**GEOLOGIC HAZARD EVALUATION AND
PRELIMINARY GEOTECHNICAL INVESTIGATION
GRANDVIEW RESERVE, PHASE 2
EASTONVILLE ROAD AND U.S. HIGHWAY 24
FALCON, COLORADO**

Project No. CS19345-115-R3

December 20, 2023

Location of
Exploratory
Borings FIG. 1

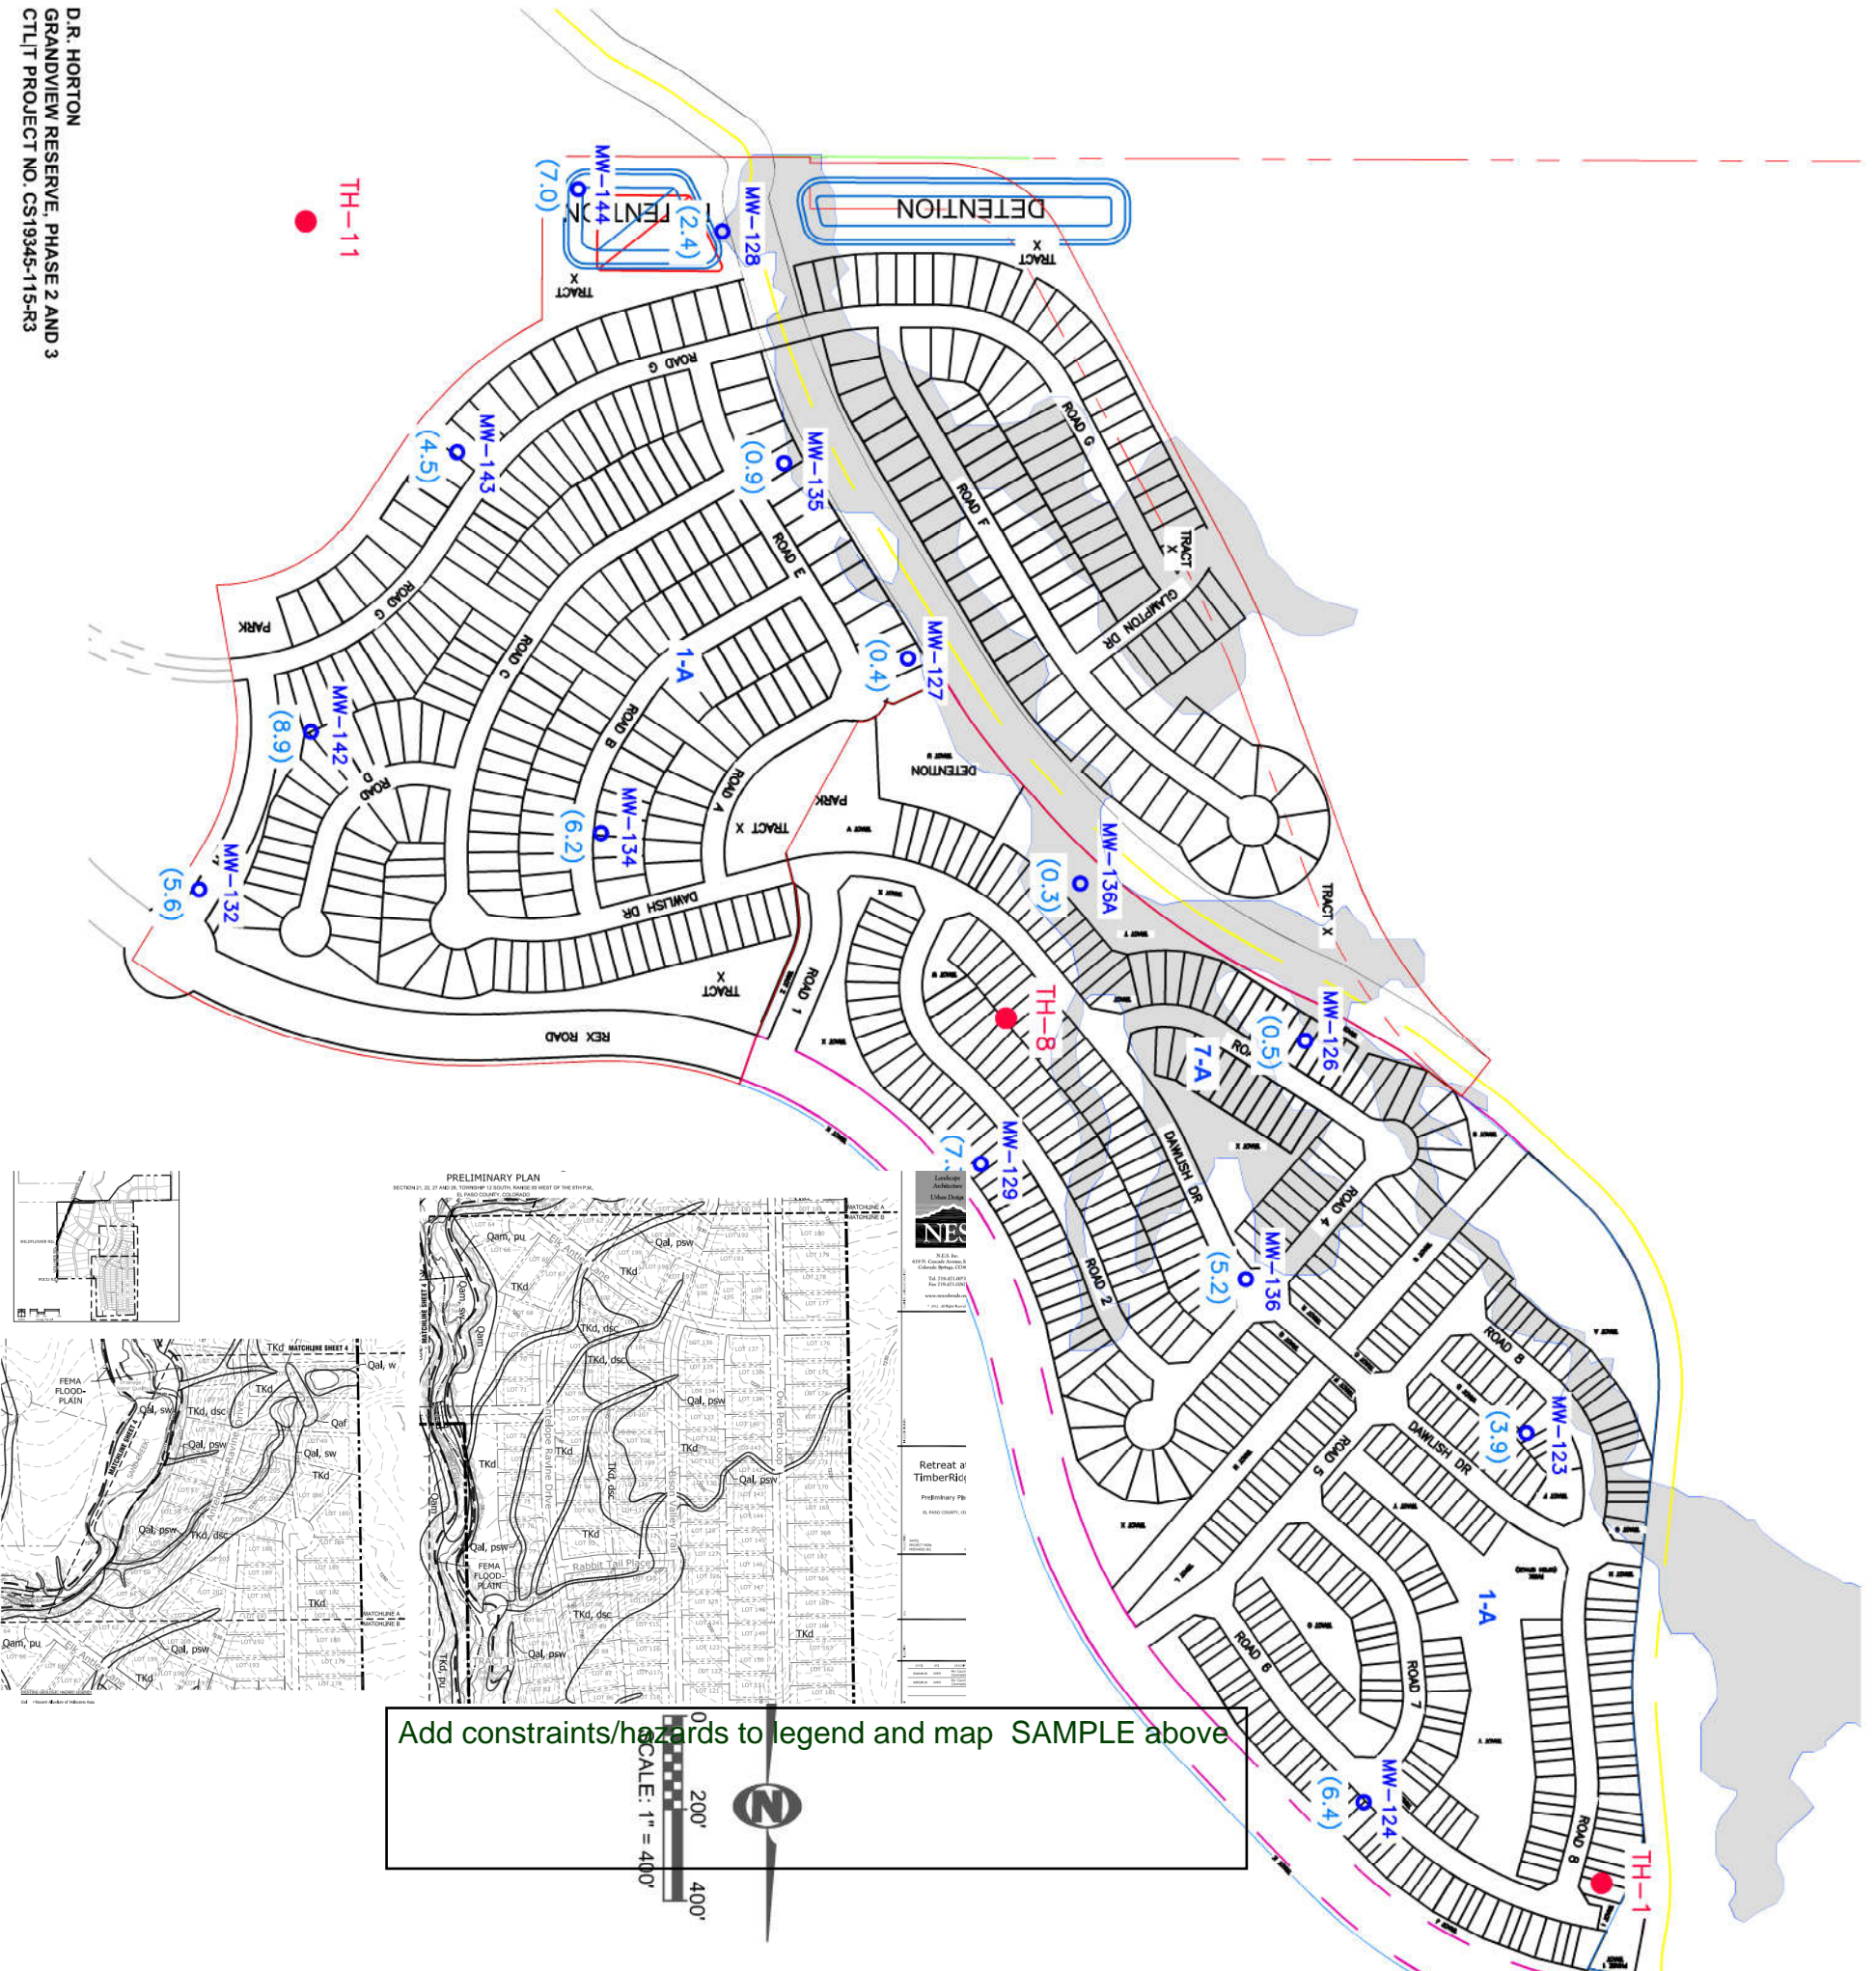
drainages and flooding are certainly constraints that should be identified

Add constraints/hazards to legend and map SAMPLE above

Add constraints/hazards to legend and map

**Groundwater
Conditions** FIG. 3

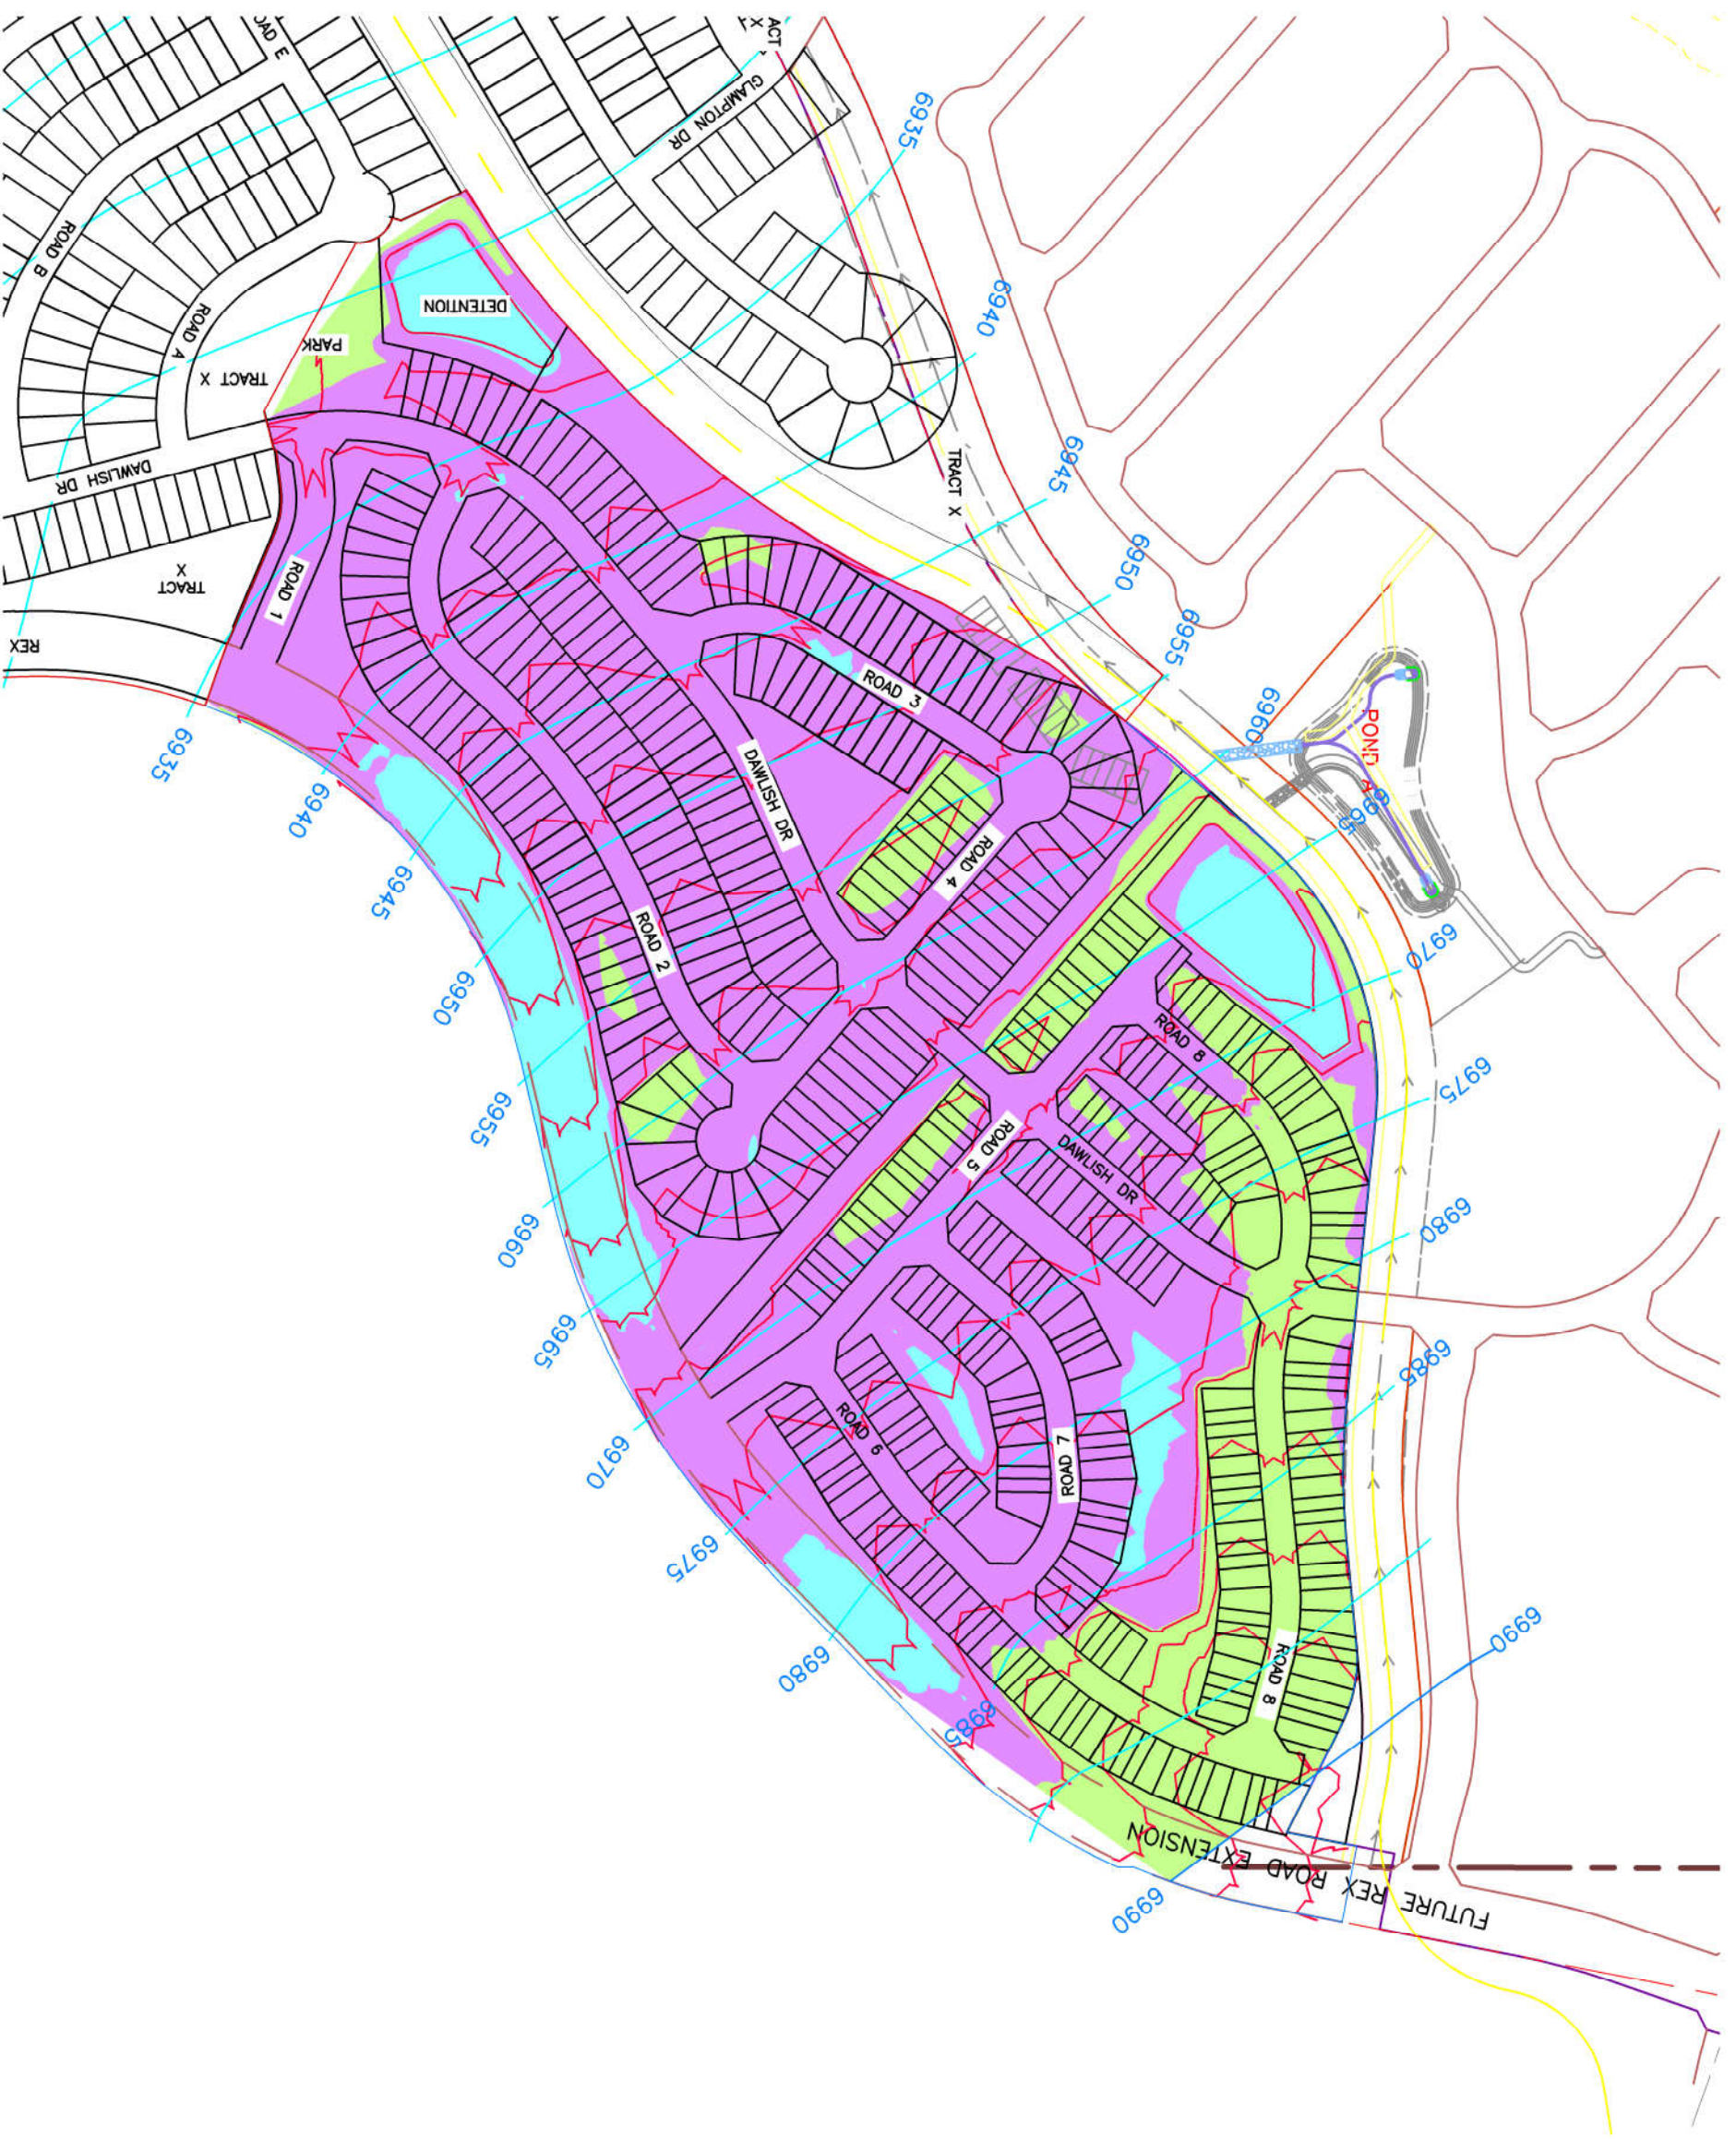
Per Figure 3 - Groundwater conditions, it shows groundwater at a depth of 0-5 ft. The proposed pond is shown to be partially in cut. Address how potential groundwater will be kept out of the pond.
